**ADDENDUM 1  
TO THE CONTRACT PROVISIONS AND CONTRACT PLANS**

**NORTHSHORE UTILITY DISTRICT  
CONTRACT NO. 2020-01; LAKE FOREST PARK RESERVOIR AND BOOSTER  
STATION UPGRADES**

**G&O #19670**

**ISSUED THIS DATE: WEDNESDAY, NOVEMBER 4, 2020**

**1 TYPICAL WATERPROOFING REPAIR SECTION**  
SCALE: 1 1/2"=1'-0"

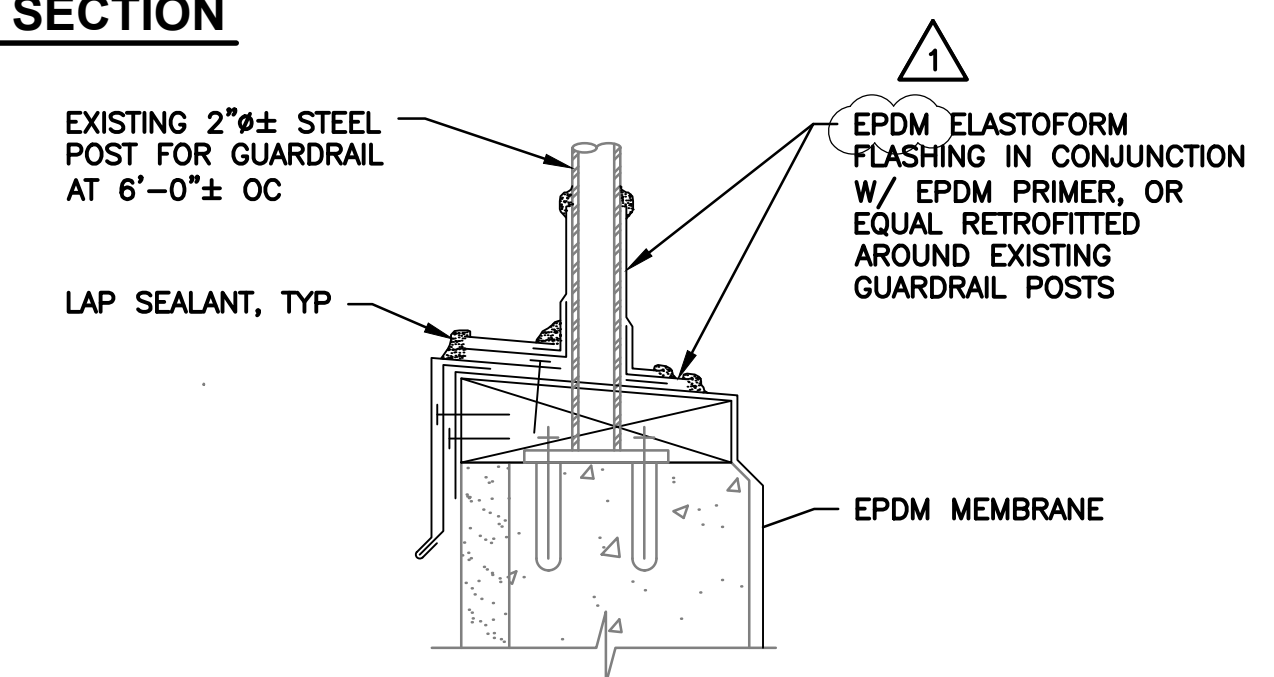
**DELETE** Sheet 7 of 28 in its entirety and **REPLACE** with the attached revised Sheet 7 of 28.
